## **Access Compliance Report Public Rights-of-Way** (Curb Ramps)

Intersection ID: 52487 Main Street: WHITEHALL\_EXECUTIVE\_CENTERs SDStreet: ORLICK\_DR Location: S

ADA ID: 0AFBD9825EC8 Ramp Type: Perp Initial Pass/Fail: Fail **Overall Compliance: No Severity Score:** 12.5

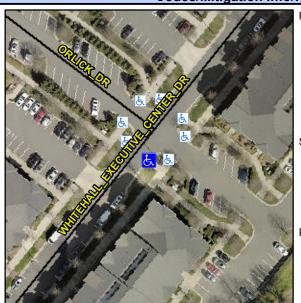
/Possible Solution		Field Measurements/Component Compliance					
Possible Solutions:		Comp	liance Description	Data	Compli	ance Description	Data
Remove & Replace Entire Ramp.		N/A	Ramp Length (in)	69.5	No	Ramp Slope (%)	9.3

•	Yes	Ramp Width (in)	67.0	Yes	Ramp XSlope (%)	0.9
		N/A	Flare Type LT	N/A	N/A	Flare Type RT	N/A
		N/A	Flare Slope LT (%)	N/A	N/A	Flare Slope RT (%)	N/A
		N/A	Flare Traversable LT?	N/A	N/A	Flare Traversable RT?	N/A
		N/A	Landing Length (in)	N/A	N/A	DWS Provided?	N/A
Surveyor Notes:		N/A	Landing Width (in)	N/A	N/A	DWS Contrast?	N/A
N/A		N/A	Landing Slope (%)	N/A	N/A	DWS Length (in)	N/A
É		N/A	Landing X Slope (%)	N/A	N/A	DWS Full Width?	N/A
		N/A	Landing Curb? (Y/N)	N/A	N/A	DWS Offset (in)	N/A
		N/A	Shared Landing?	N/A			
PROW/ADA:		N/A	Gutter Ponding?	N/A	N/A	Gutter Slope (%)	N/A
Not Found, R304.2.2		N/A	Gutter Lip Ht (in)	N/A	N/A	Gutter X Slope (%)	N/A
·		N/A	Painted X Walk1?	No	N/A	Painted X Walk2?	N/A
			X Walk 1 Direction	To NW		X Walk 2 Direction	N/A
		N/A	X Walk 1 Width (in)	N/A	N/A	X Walk 2 Width (in)	N/A
			X Walk 1 Slope (%)	1.9		X Walk 2 Slope (%)	N/A
			X Walk 1 X Slope (%)	1.1		X Walk 2 X Slope (%)	N/A
